Development Assessment Team Northern Beaches Council PO Box 82 Manly, NSW, 1655

Mod 2024/0697 – DA 20128/0563 Lot 27 DP28669 – 950 Barrenjoey Road, Palm Beach

FIG 2: Existing rainwater tank in proposed location on plan

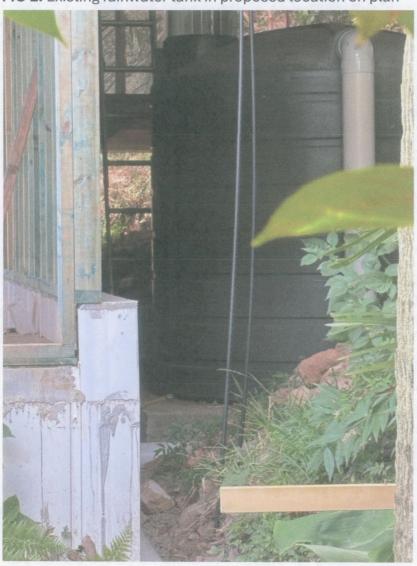
There is already in existence a rainwater tank in this location, installed at the time of initial site excavation. See Fig 2. We are unable to see how an additional tank could be placed here without using the creek as access. If the creek is to be used as access for placing the additional tank, what precautions are to be taken to preserve the natural environment of this area?

FIG 3 below shows the positioning of W14, W22 & W23 referred to above.

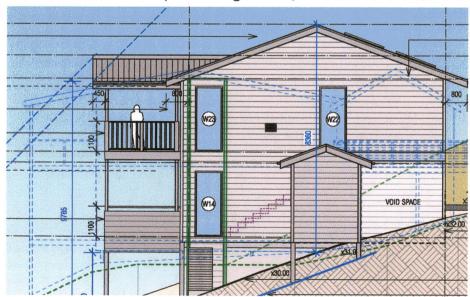
In relation to the windows on the south-east side, the initial DA approval dated 14 December 2018 states at 2 on page 4

(a). Windows W14, W22 and W23 on the south-east side elevation and W18 on the north-west elevation are to:

FIG 4: shows the reworked design as seen from 948 Barrenjoey Road

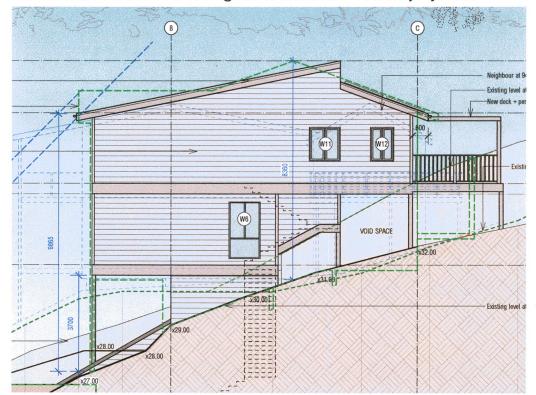
In 2020 the applicant filed a modification, Mod2020/447, which in part reworked the windows on the south-eastern boundary. In the Statement of Modification dated 18 November 2019, page 4, the modification purpose is stated as:

"The proposed visual privacy will be improved from the original submission due to window locations, room layouts and the removal of and reduction of decks."

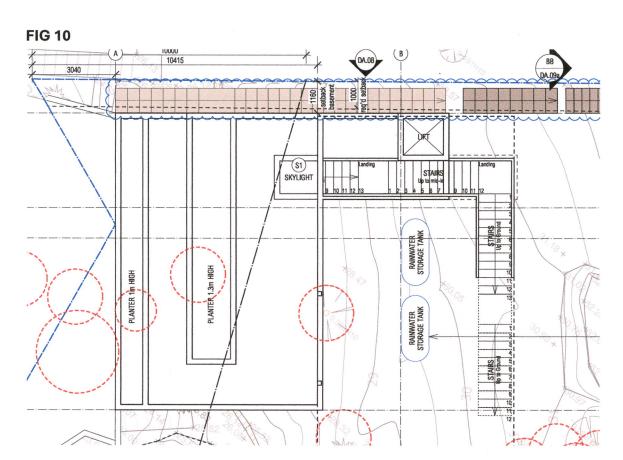
We understand the cabbage tree palms in Fig 9 have been approved for removal. Even if not removed, they will grow past the windows and not provide any privacy.

Obviously, Privacy Screens are to be fitted, to that part of the windows which do not comply with condition 2a(i) or (ii) when open. As the CC has now issued and these amendments should have been incorporated into the plans (as previously stated by Council), the plans under the current Modification 2024/0697 are incomplete and misleading. They should show:

- a) Privacy screens for windows W6, W11 and W12, to that part where there is no frosted glass when open; and
- b) An <u>opaque</u> privacy screen 1.7m high on the rear deck/pergola. in order to "restrict overlooking of the adjoining dwelling at 948 Barrenjoey Road".

**FIG 11**

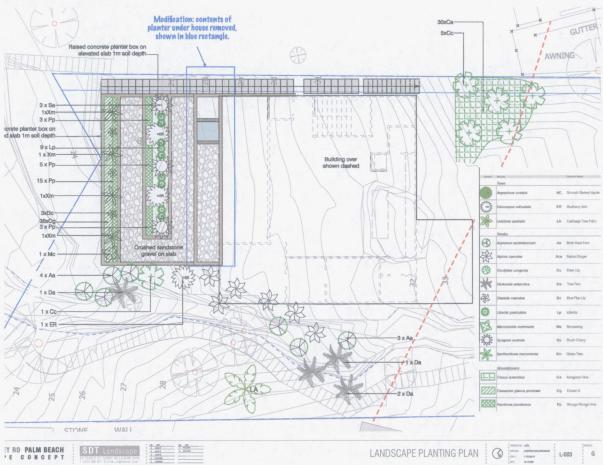
The Landscape Plan lodged with Mod 2023/0016 shows the removal of a planter not seen on the pre CC plans lodged with Council – See Fig 11

**FIG 12**

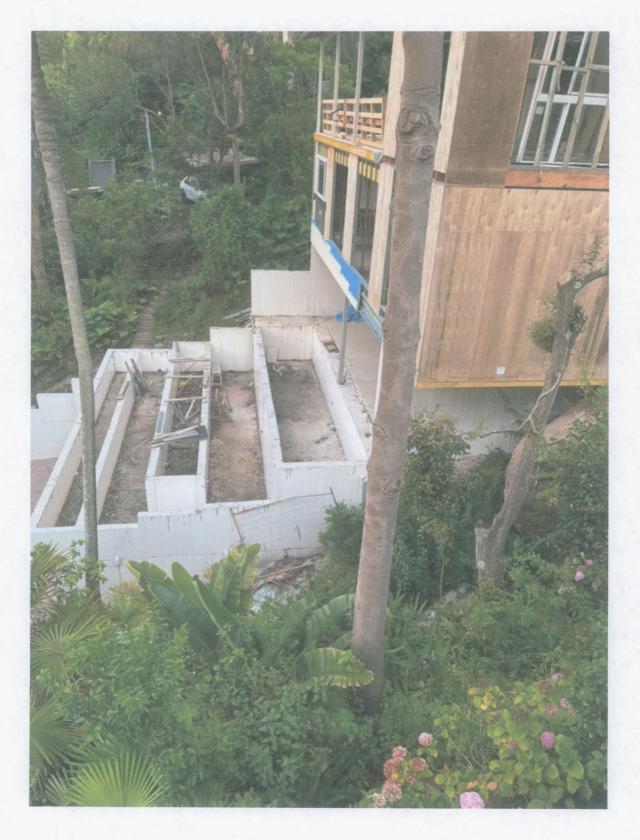
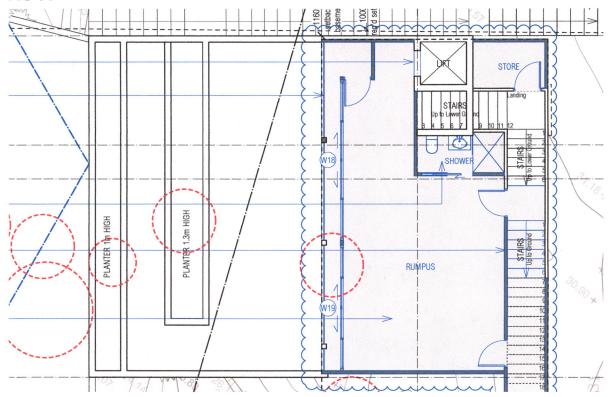
The current plan of the Lower Ground Floor shows no skylight and no planter, however, the current construction shows a planter has been constructed – see Figs 12 and 13.

Is it proposed to demolish the current construction in Figs 12 and 13 so that it is consistent with the Plan DA.02B dated 26.11.24 lodged under Mod2024/0697 – See Fig 14?
